Subject: UniStar Nuclear Energy, NRC Docket No. 52-016
Response to Request for Additional Information for the
Calvert Cliffs Nuclear Power Plant, Unit 3,
RAI 218 and RAI 229, Stability of Subsurface Materials and Foundations

Response to NRC Request for Additional Information

**RAI 218 Questions 02.05.04-03, 02.05.04-09, 2.05.04-10 and 2.05.04-15
and**

RAI 229 Questions 02.05.04-17 and 02.05.04-19,

Figure 24
Finite Element Model Used to Calculate Induced Stresses due to Foundation Loading

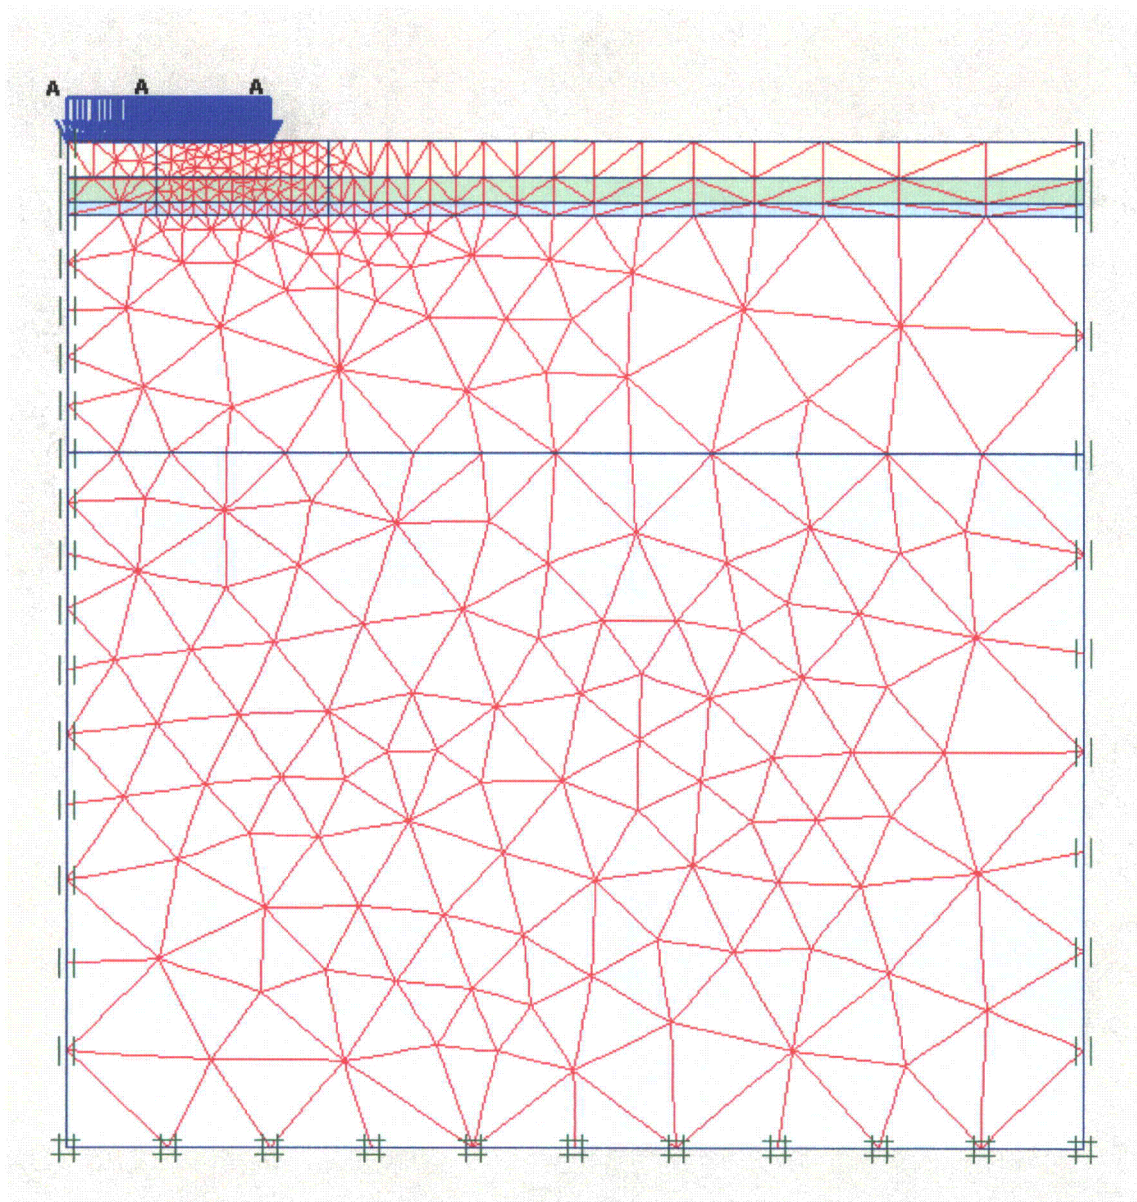
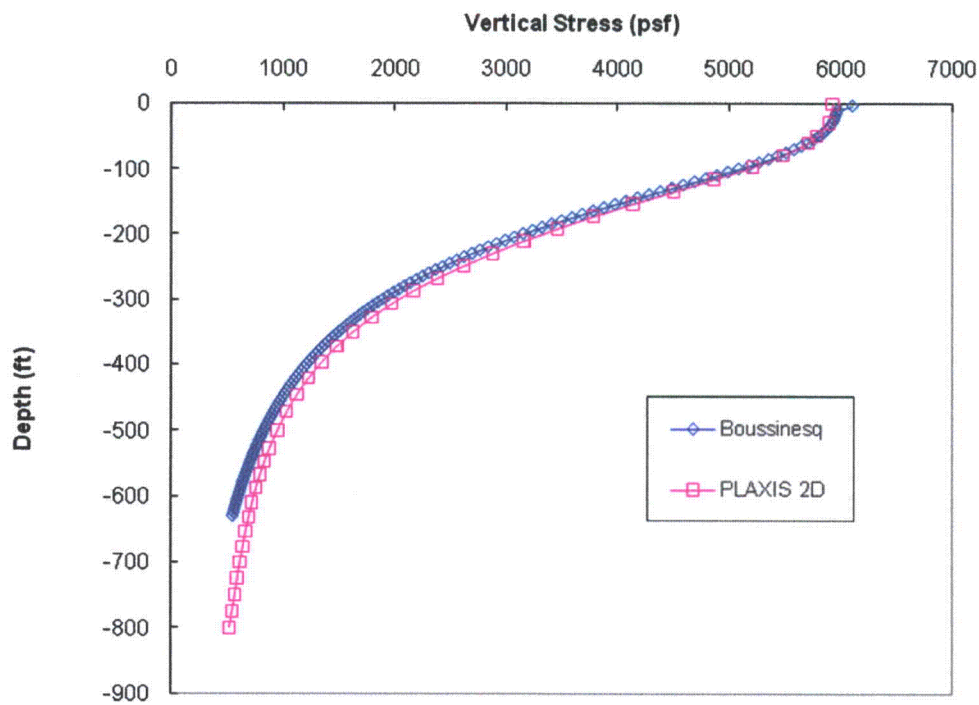
1. Please explain the adequacy of the initial stress conditions selected in your FEM settlement calculation.
2. Please evaluate the possibility of any additional settlement caused by seismic event at the site.
3. Please address the effects of soil parameter variation and spatial variability on your settlement analysis.
4. Please address differential settlement between the nuclear island and adjacent structures, and compliance with the U.S. EPR standard design.
5. Please justify the assumptions, especially the determination of stress increases in each layer, used in the hand calculation of settlement you performed.

To further investigate the validation of the assumption for the CCNPP Unit 3 settlement calculation, a finite element numerical model was generated to replicate the subsurface conditions at boring log B-301. A numerical model was generated using PLAXIS two-dimensional (2D) finite element analysis software. The model includes a circular footing loaded uniformly with 5,930 psf. The layer thicknesses and soil properties considered in the model were based on boring B-301 (Table 16). The axisymmetric finite element model is shown in Figure 24. Fifteen node triangular elements were used with linear elastic material properties.

The vertical stresses beneath the center of the foundation are presented in Figure 25 from finite element simulations and Boussinesq solutions. It is clear from the comparison of the two approaches that the difference between the theoretical solution without any stiffness input and a layered subsurface model is marginal. This finding indicates that the assumption, for the determination of stress increases in each layer, used in the hand calculation of settlement is valid and does not affect the settlement results.
